# TECHNICAL SERVICE BULLETIN

Bulletin Number: Z-16-01-E

## SUBJECT: 2014-2015 RZR XP 1000 / XP4 1000 and 2015 RZR / RZR S / RZR XC / RZR 4 900 FUSE BOX SEAL REPLACEMENT

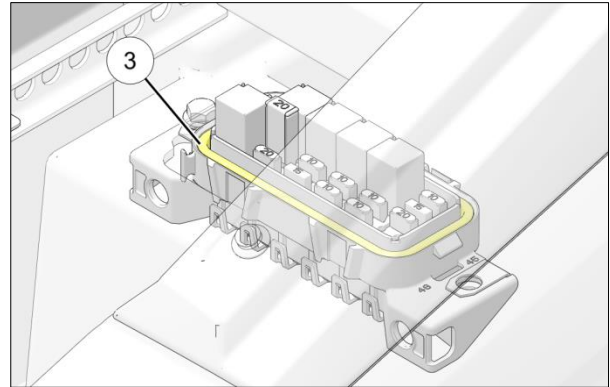
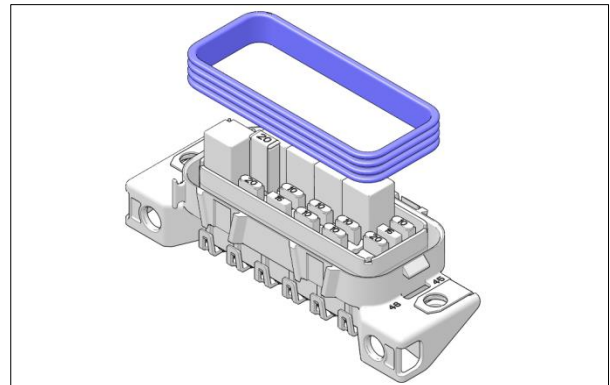
3. Using a seal pick, remove the seal ③ from the fuse box.

4. Install the updated blue seal.

**NOTE:** Before installing the updated seal, make sure the fuse box is free of any water or debris and inspect for damaged components. *If the fuse box is damaged or corroded, take photos of the damaged fuse box and entire vehicle. Start an Ask Polaris - Authorization: Non-Cosmetic & Polaris ESC case. Attach the photos to the case and for the CONCERN, CAUSE and CORRECTION enter "SB Z-16-01-E". Enter the appropriate flat rate time, and submit the case to Polaris.* Continue to step 5.

**Updated Seal (Blue)**
